# Manual Supplement

| Manual Title:  | 2640A/2645A NetDAQ Service | Supplement Issue: | <b>3</b> |
| Part Number:   | 942615                     | Issue Date:       | 8/05     |

Figure A.

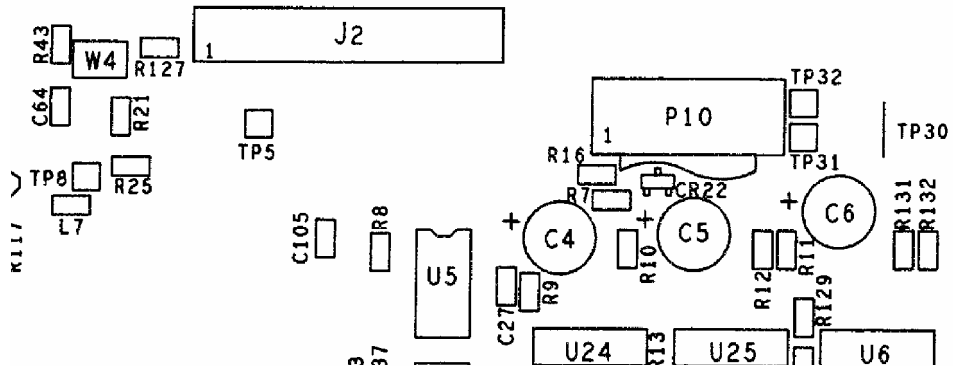
On pages 6-14 and 7-3, Figures 6-2 and 7-1, add C105 as shown in Figure A.

Change: C10,35,53,81/CAP,CER,1000PF,+5%,50V,C0G,1206/867408/4  
 To: C10,35,53,81,**105**/CAP,CER,1000PF,+5%,50V,C0G,1206/867408/5

Figure B.

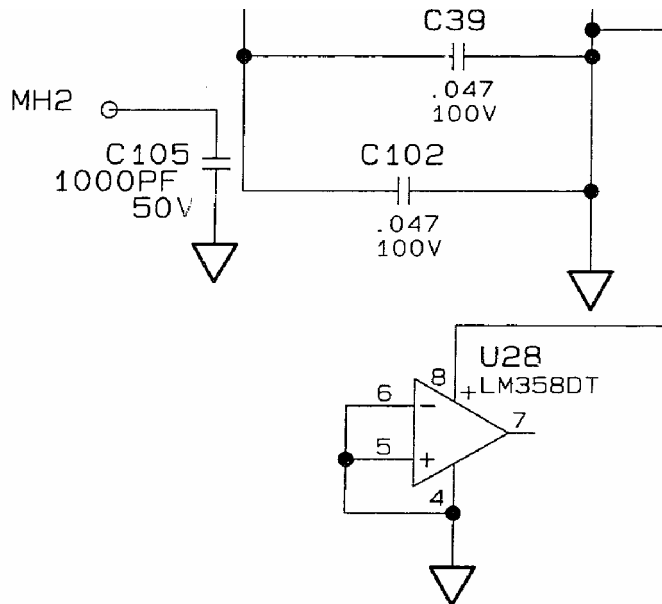
On page 7-4, Figure 7-1, add C105 as shown in Figure B.

Figure 4-1. Performance Test Setup

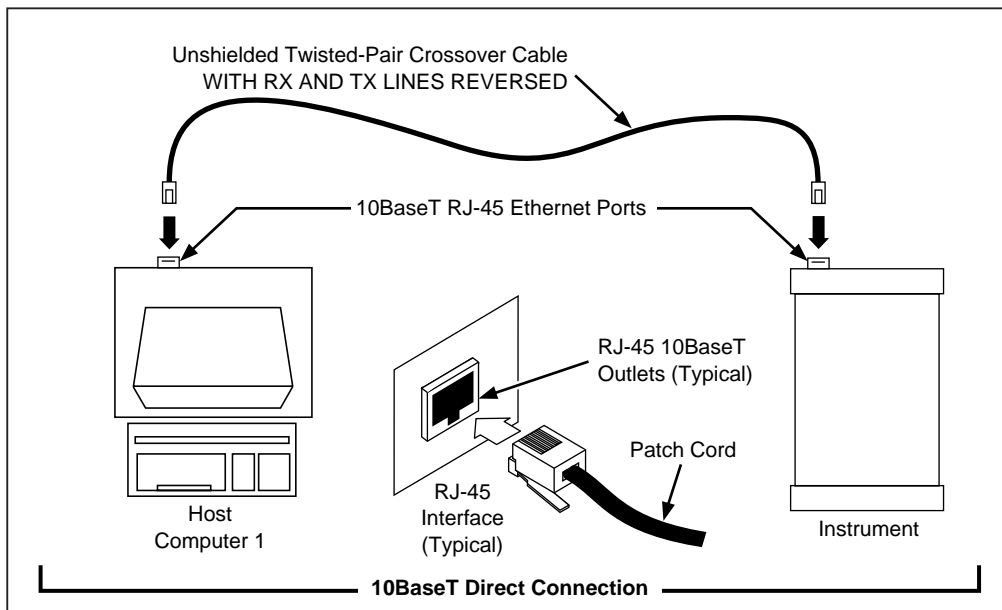
The 10Base2 Ethernet port has been eliminated on the 2640A and 2645A. Any reference to the 10Base2 or coaxial network connections should be disregarded.

On page 4-5, replace Figure 4-1 with the following:

1. **Connect the Instrument and Host Computer** Make the network connections to the instrument and the host computer using a suitable RJ45 UTP Crossover cable as shown in Figure 4-1.
